Certificate of Appropriateness

2229 N. Terrace Ave. North Point South HD

PTS ID 114638 COA driveway and retaining wall

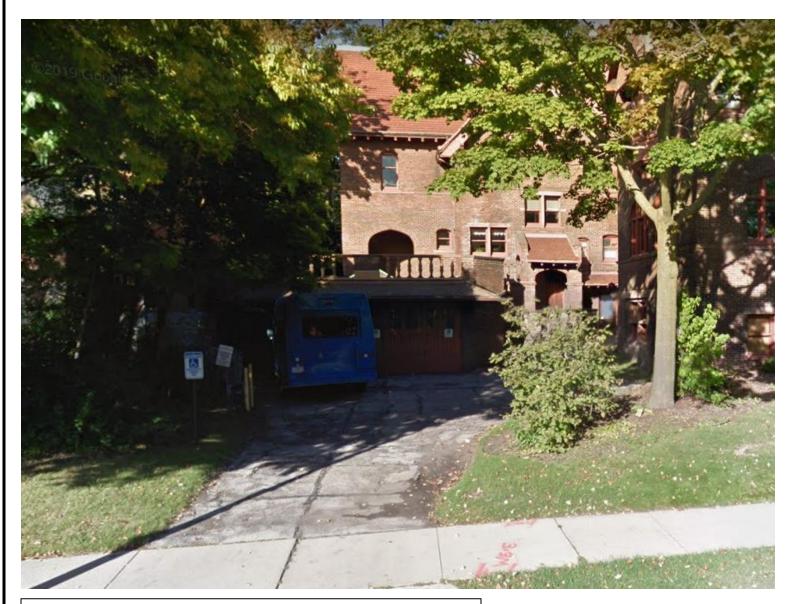
Photo ca. September 2015 indicates the previous condition of the driveway – cracked, asphalt paving.

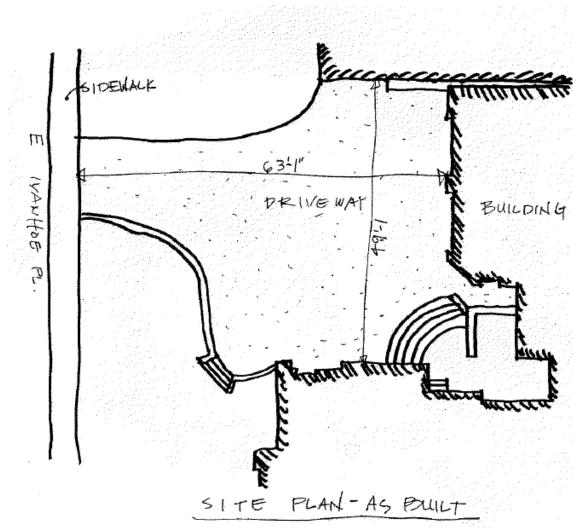
Recent photo of the property indicates that the driveway has been repaved with concrete. This is found acceptable by staff, but subject to proper drainage inspection. If design alteration is required per subsequent drainage inspection, changes must be presented to HPC staff.

If there are any design changes required to address drainage, the driveway plan must come back to HPC Staff for approval.
